UNITED STATES PATENT AND TRADEMARK OFFICE

APPLICATION NO.	FILING DATE	FIRST NAMED INVENTOR	ATTORNEY DOCKET NO.	CONFIRMATION NO.
10/826,272	04/19/2004	Kazuhiro Fujii	SN-US045038	9912
22919 7590 04/18/2007 GLOBAL IP COUNSELORS, LLP 1233 20TH STREET, NW, SUITE 700 WASHINGTON, DC 20036-2680			EXAMINER LUONG, VINH	
			ART UNIT 3682	PAPER NUMBER
SHORTENED STATUTORY PERIOD OF RESPONSE			MAIL DATE	DELIVERY MODE
3 MONTHS			04/18/2007	PAPER

Office Action Summary

FIG. 2

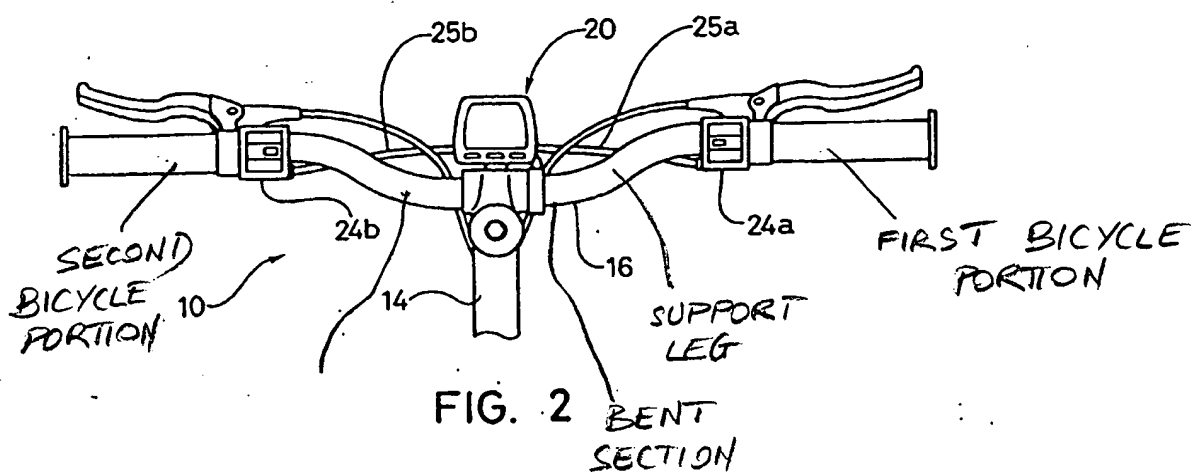
a mounting portion 41 (FIGS. 3, 9, etc.) configured to be selectively secured to a bicycle portion (i.e., a handgrip) of a bicycle (FIG. 2, see Attachment 1 hereinafter "Att. 1"), the mounting portion 41 including a switch mounting structure (unnumbered, see, e.g., FIGS. 9 and 10 of Att. 1); and

Regarding claim 6, the operating axis P of the operating member 42 is capable of being non-parallel to a center axis of the portion (FIG. 2 of Att. 1) of the bicycle as seen by adjusting the position of the mounting portion 41 along the handle bar 16 as seen in FIG. 2.

Regarding claim 11, Ichida teaches an electrical bicycle shift control assembly comprising: a first shift control device 24a (FIG. 2) including a first mounting portion 41 (Att. 1) configured to be selectively secured to a first (right handgrip) bicycle portion of a bicycle 10 (FIG. 2 of Att. 1) and a first electrical shift control switch portion 40 mounted to the first

Regarding claim 13, the first mounting portion 41 includes a band section (FIG. 9 of Att. 1) and a computer support leg 16 (FIG. 2 of Att. 1) extending from the band section, and the bicycle computer unit 20 is attached to the computer support leg 16 of the first mounting portion.

Regarding claim 14, the computer support leg 16 includes a bent section (FIG. 2 of Att. 1) such that the bicycle computer unit 20 is longitudinally offset from the band section (FIG. 9 of Att. 1) along the first bicycle portion (FIG. 2 of Att. 1).

FIG. 4

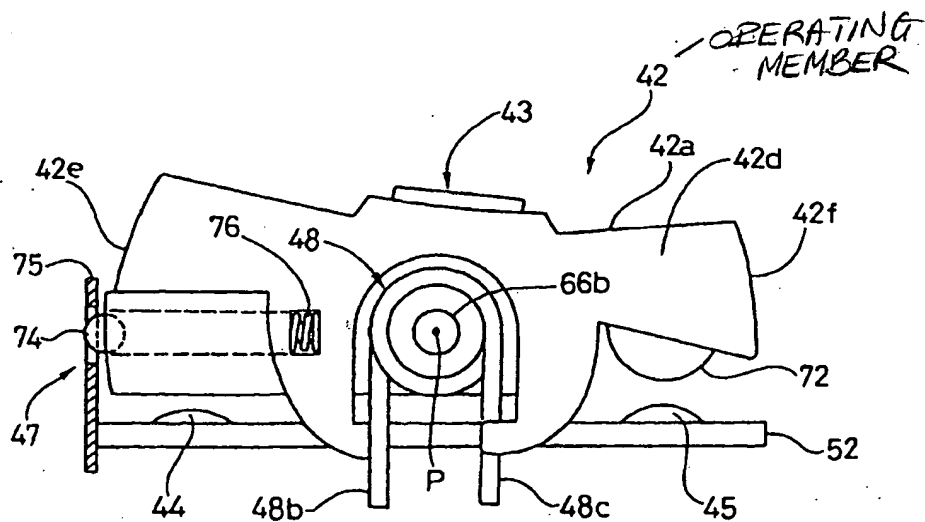
Regarding claim 3, the operating member 42 is further arranged and configured to be selectively moved relative to the mounting portion 41 between the neutral position (FIG. 4, see Brief Description of the Drawings) and a second actuating position (FIG. 6) that is spaced from the first actuating position (FIG. 5).

Regarding claim 5, the operating member 42 of the electrical shift control switch portion 40 is further arranged and configured to rotate about an operating axis P (FIGS. 4, 15, 16, and 18) between the neutral position and the first and second actuating positions. See paragraph [0032] and claims 1-35.

Regarding claim 7, the operating member 42 of the electrical shift control switch portion 40 is further arranged and configured such that the first and second actuating positions are arranged on opposite sides of the neutral position (FIGS. 4-6).

FIG. 9

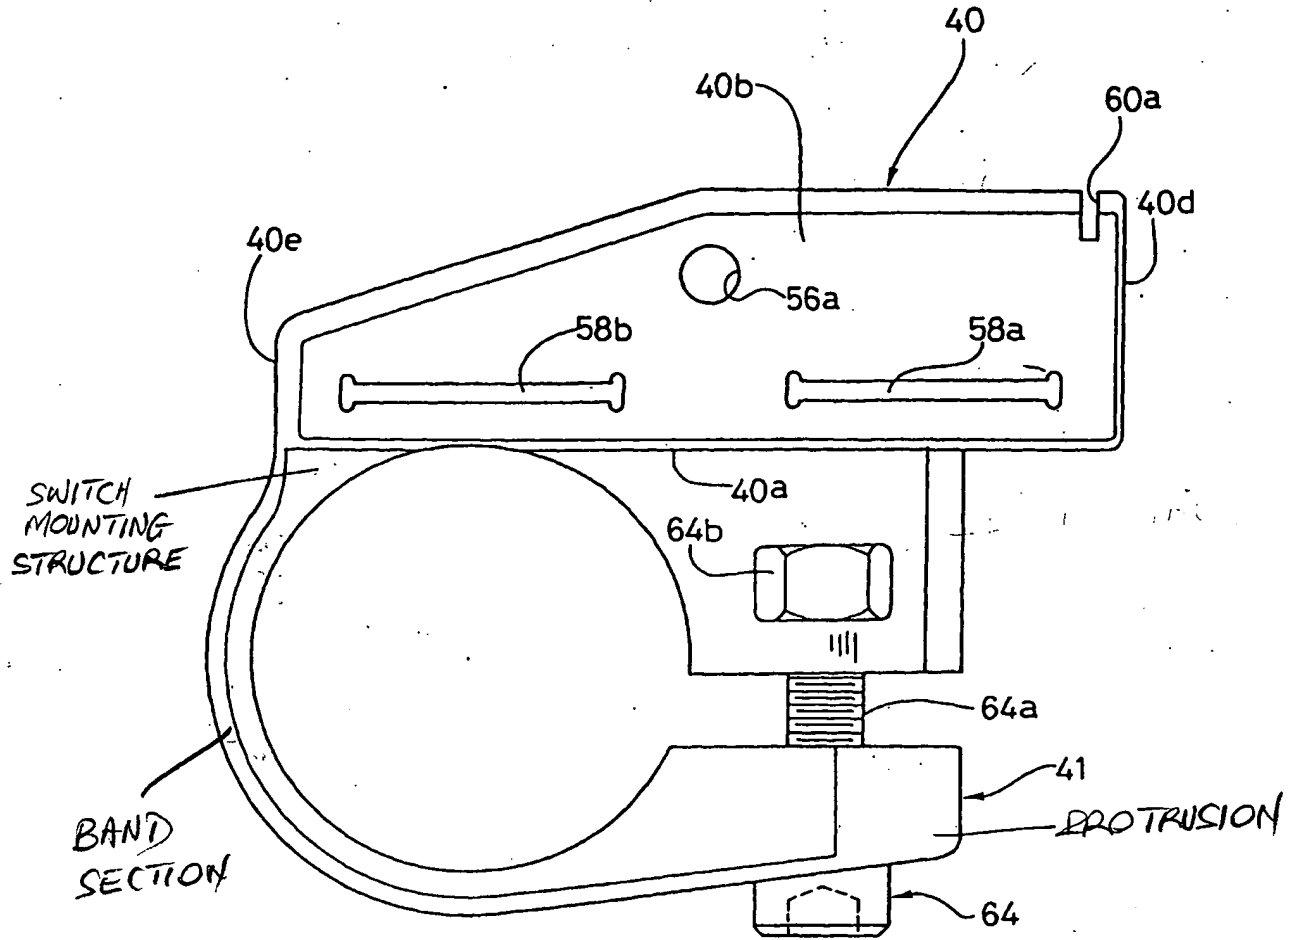
Regarding claim 2, the mating mounting structure and the switch mounting structure (Att. 1) include a protrusion (FIGS. 9 and 10) and recess 50 (FIG. 8, paragraph [0034]-[0036]) arrangement that are releasably coupled together by a fastener 64 such that the mating mounting structure is movable relative to the switch mounting structure (Att. 1) when the fastener 64 is removed.

Fig. 8

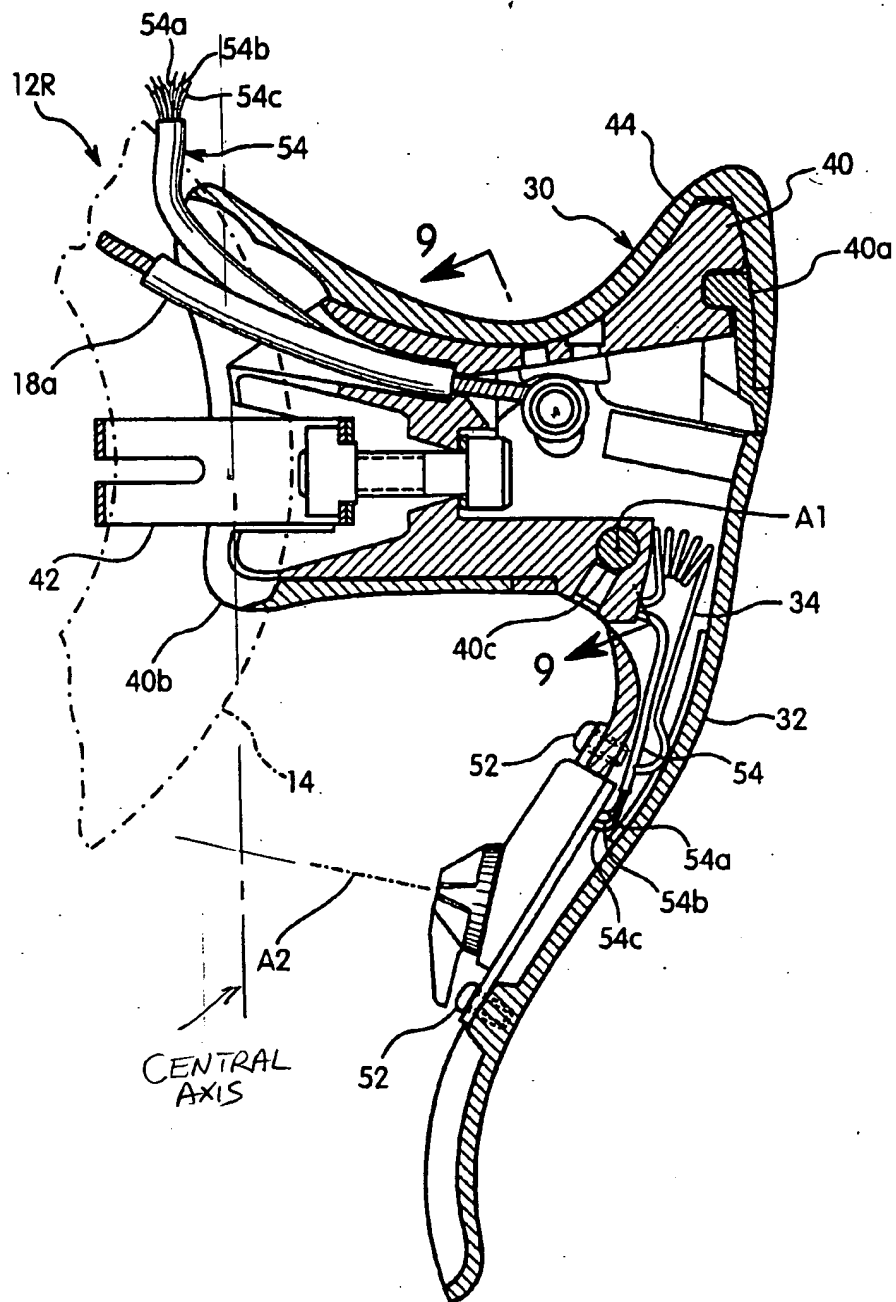
Regarding claim 26, the mounting portion 42, 40 includes a curved mounting surface 42 extending about a central axis (see FIG. 8 of Attachment 2 hereinafter "Att. 2") to contact the bicycle portion 14 and the operating axis A2 is non-parallel to the central axis (Att. 2).

Regarding claim 27, the operating axis A2 intersects the curved mounting surface 42 of the mounting portion 42, 40 as seen in, e.g., FIG. 8.
